161 Walnut Street

I think we are very close to getting an application that meets the required details and information for Commission review. Please provide an accurate sketch that shows the windows and trim with all of the measurements requested by the Commission, specifications for the trim that will be used, and a revised specification for the Harvey windows that documents the measurements of the window that will work for this project.

**APPLICATION FOR LOCAL HISTORIC DISTRICT CERTIFICATE OF  
APPROPRIATENESS, NON-APPLICABILITY, OR HARDSHIP**

PROJECT ADDRESS: 161 Walnut St Newtonville MA 02460

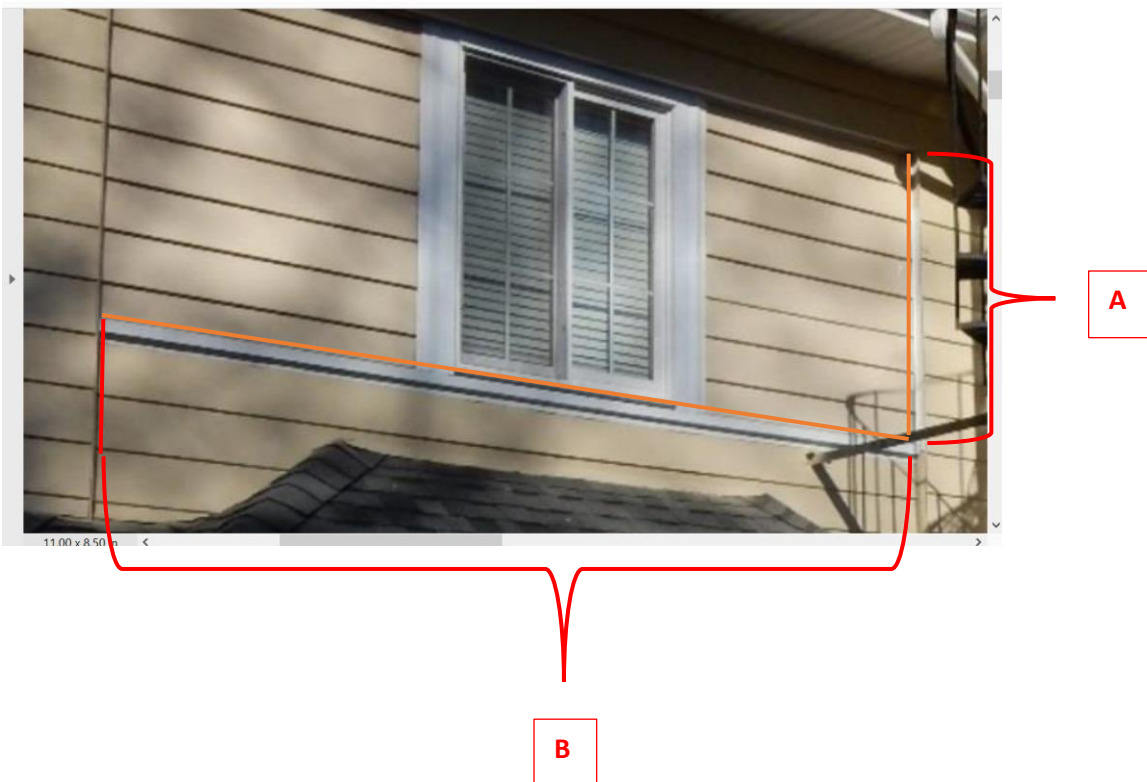
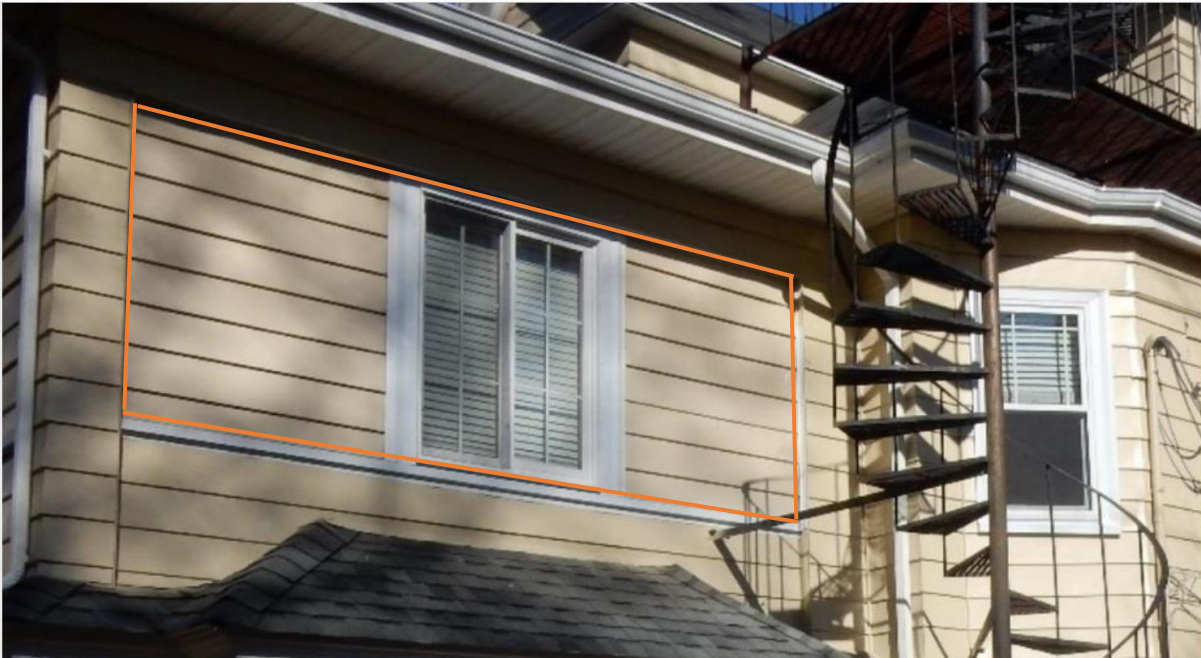
There was a request that the new windows be centered over the triple window below, but that assumes that the small bay and triple windows below are centered in that area of the building. Since we don't know if the existing first story bay and windows are centered, it makes more sense equally fill the second-story area per the requirements and information spelled out in this document and then also provide a sketch showing how that will relate to the small bay and windows below. That sketch should include measurements for the small bay: distance from the left and right house corners to the left and right bay walls; measurements for the distance between left and right bay wall edges to the start of the left and right window trim; and the measurements for the three windows.

1. The enclosed triple windows and trim must fill the area of the existing white trim boundary. The existing white trim boundary will remain. If the existing white trim boundary needs to be replaced, the owner must let the Commission know and provide the existing dimensions.
2. The sketch must show the vertical interior dimension (A) and horizontal interior dimension (B) of the existing white trim boundary (outlined in orange.)

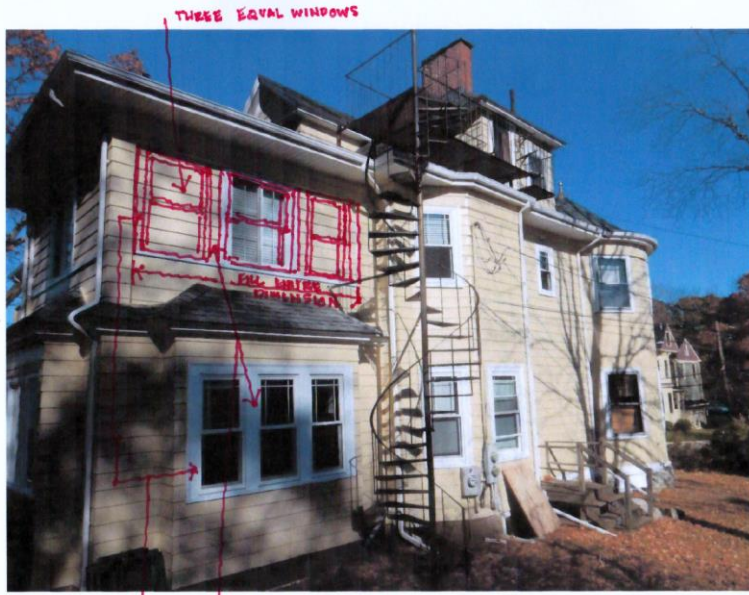
- c. The vertical mullions must match the width (H) and details of the two vertical mullions of the triple window below.

The sketch must show the width of the two vertical mullions (H)

d. With all of these elements measured, the height and width of the three windows can be determined. The sketch must show the height (I) and width (J) of the windows, as well as the other required measurements. The height and width must be identical for each window.

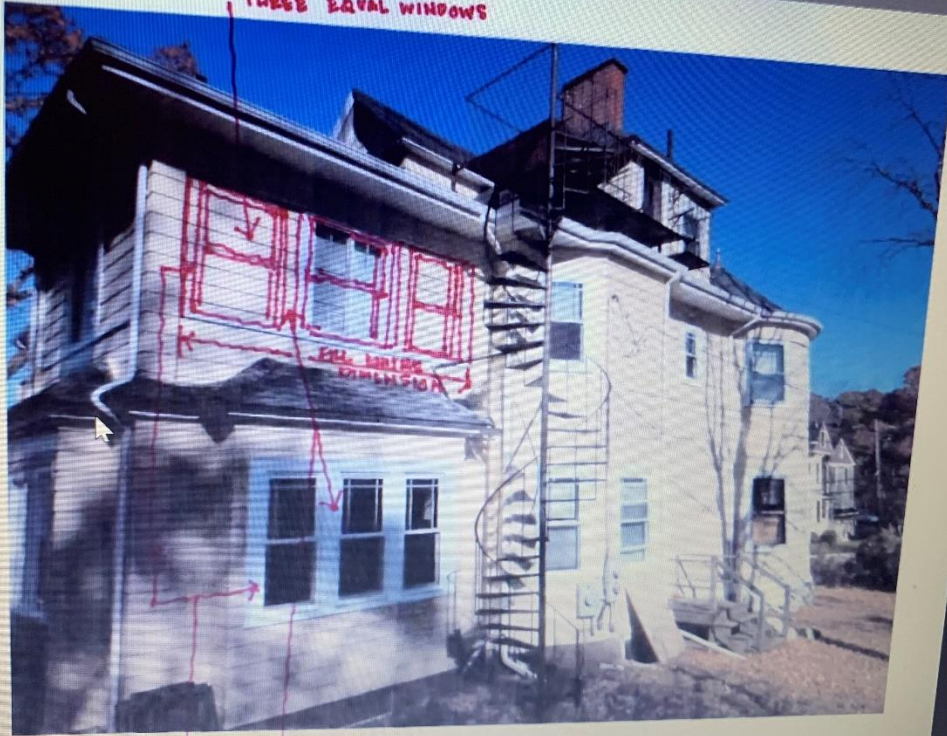
THESE EQUAL WINDOWS

MAKE TRIM DIMENSIONS IDENTICAL

Propose R3 Window and look like .

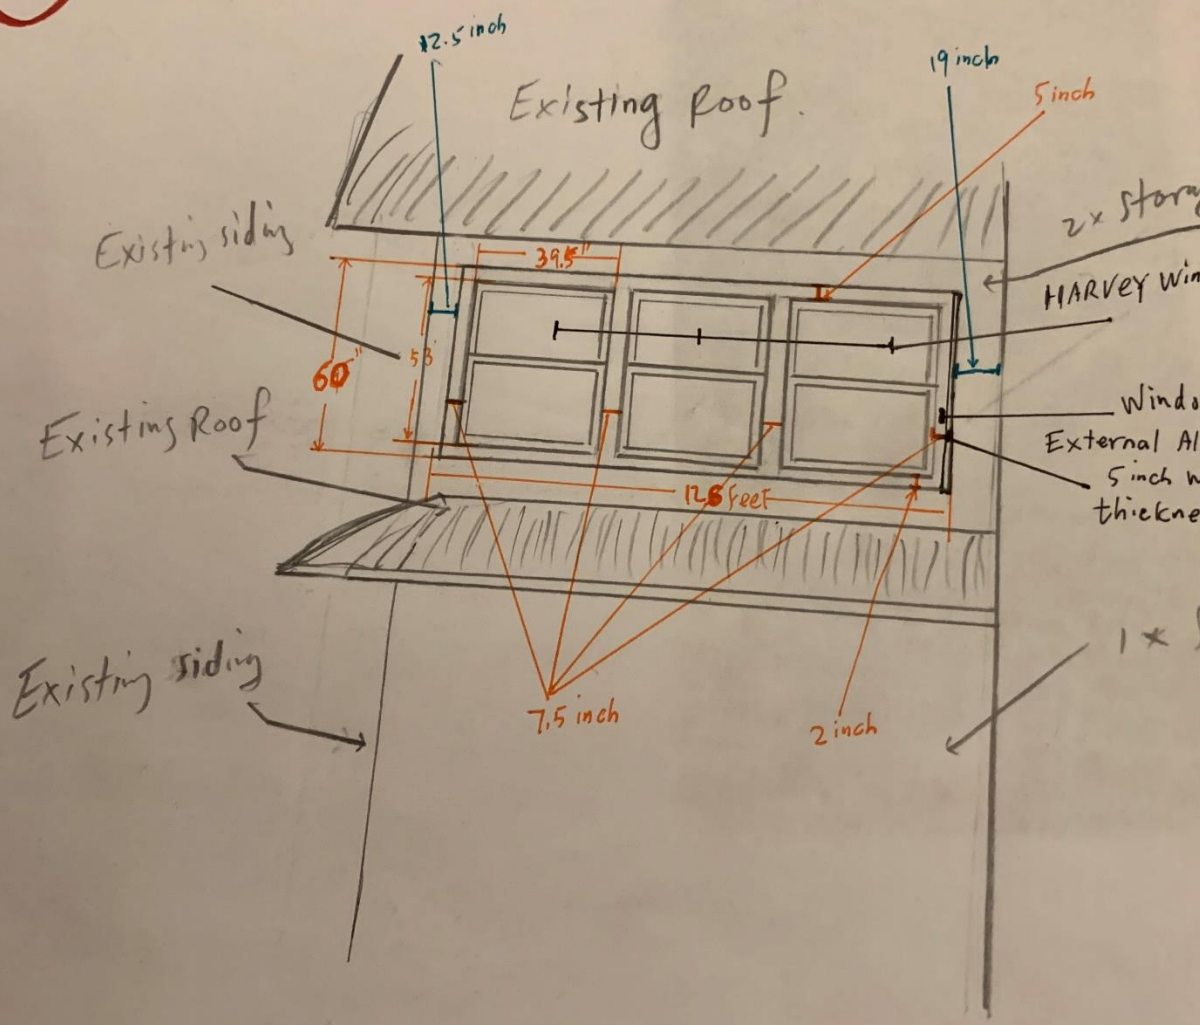
- b. The trim at the top and bottom must match the width and details of the top trim (F) and the triple window below.

The sketch must show the width of the trim at the top (F) and the bottom (G).
